**Frontloading washing machines EWM1000 and EWM1000+
Appliance does not spin respectively spinning cycle is stopped**

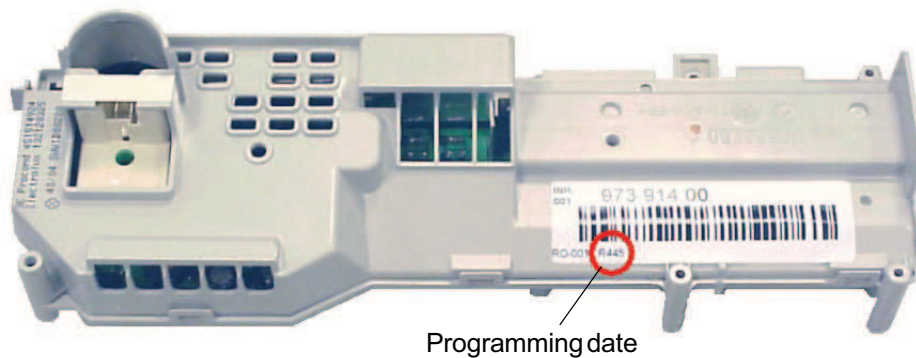
This fault may result with appliances with EWM1000 and EWM1000+ control electronics, which have been manufactured at works in Nuremberg by series no. 443 Please find all PNCs concerned in the appendix. With appliances showing this fault, please replace the control electronics.

With the new software the tuning of motor control and motor was optimised so that a proper spinning is guaranteed.

With appliances from series no. 444 the new software was applied at works in general.

The spare part electronics from the programming date R445 will be supplied with the modified software. The production date of the spare part electronics can be found on the spare part label.
